NUCLEAR LOGISTICS INC

Letter #QA-2044

Subject: 10CFR21 notification

Technical Bulletin TB-0948431-02 PCP Firing Board P.C. Assemblies

Figure 1

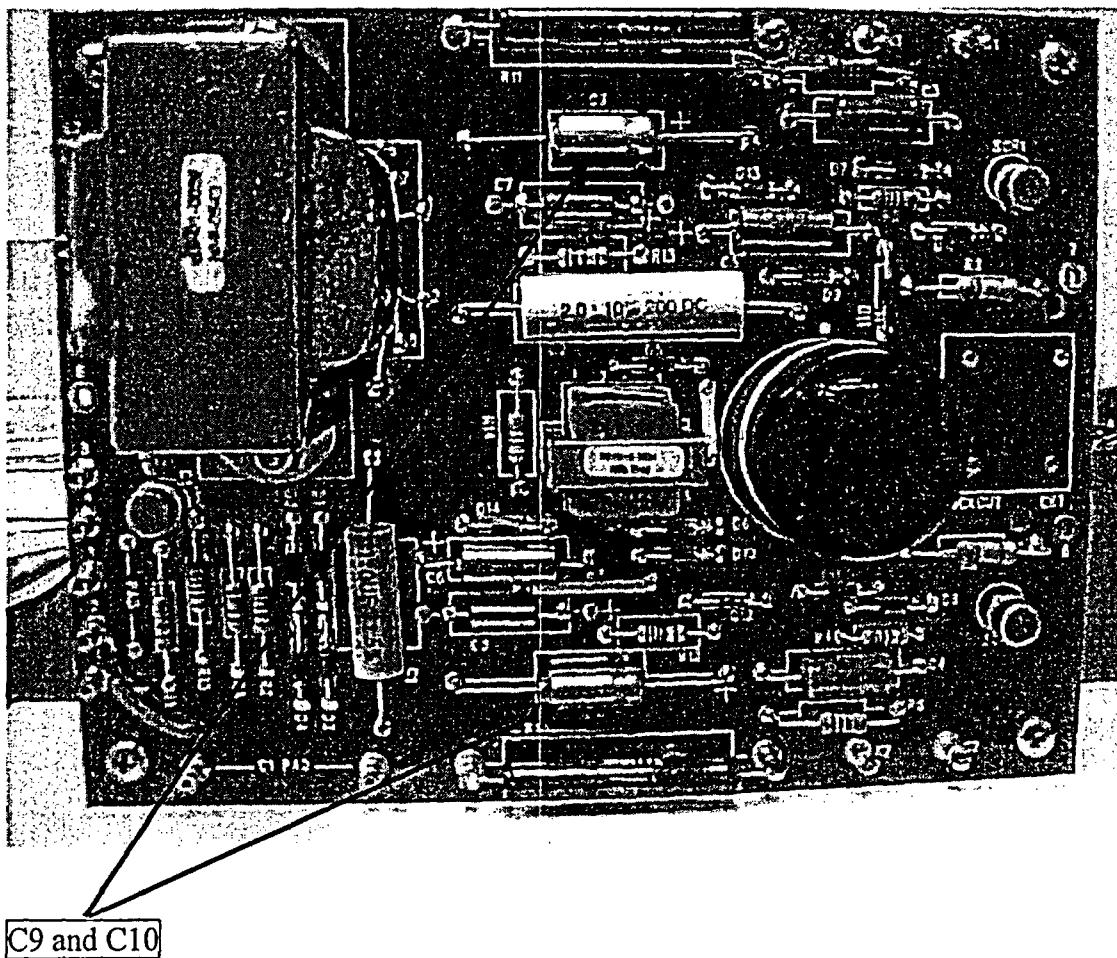
- Examine C9 and C10 on all three tiers of the firing board assembly (6 capacitors total) as follows:
 - Inspect the C9 and C10 capacitors (refer to figures 1 and 2 for location and identification). The capacitors with the shortened life are labeled with 109D. If the capacitors are labeled other than 109D, they are acceptable and the circuit board can be used.
 - While examining the circuit boards, inspect the capacitors for evidence of degradation (yellow color or black/brown burn spots). Discoloration is a

good early indication of capacitor degradation. Discoloration will appear on the capacitors before the capacitance starts to decrease.

- If there is evidence of capacitor degradation, the circuit board should be replaced.
- If there are not burn spots on the capacitors, the capacitor is acceptable for continued use. The capacitors on the circuit boards that are in service should be inspected monthly until the boards can be removed and the capacitors replaced.

Firing board assemblies with capacitors labeled 109D should be returned to NLI for rework and retesting. As an alternative, NLI can supply the replacement capacitors for installation on the circuit board by the plant.

Figure 2

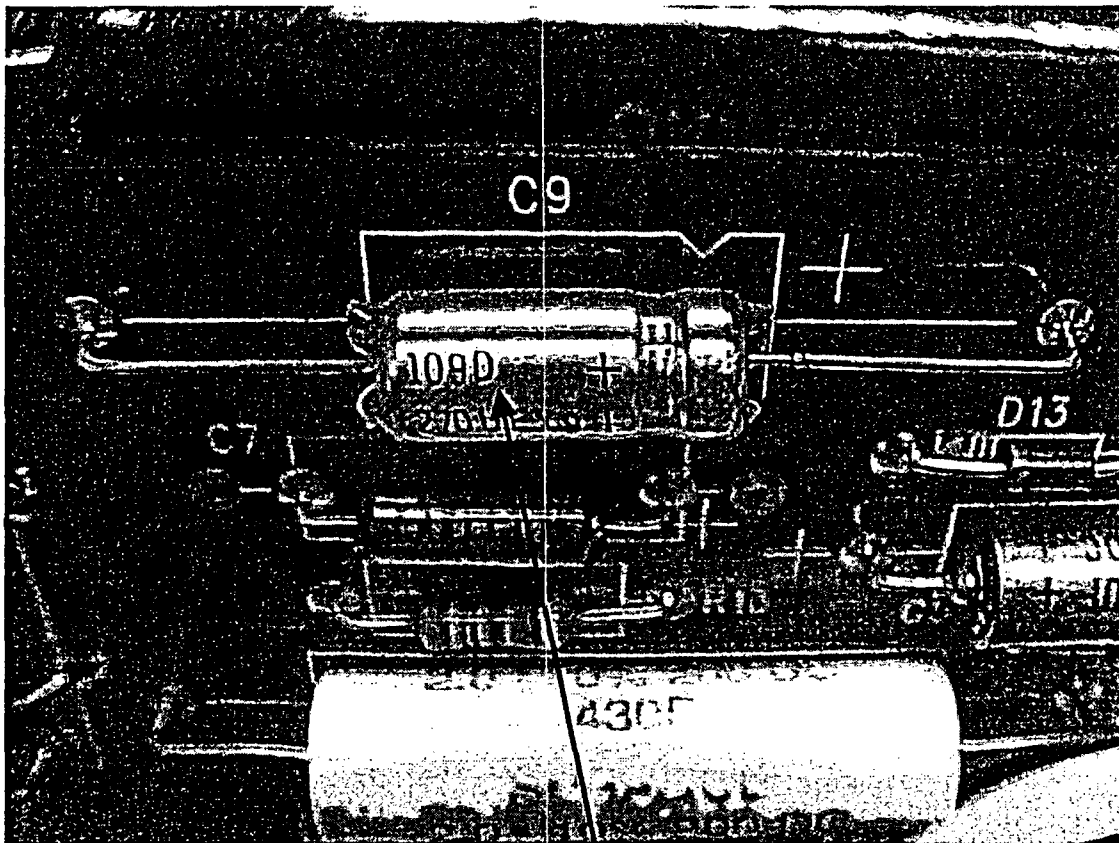
Note case markings
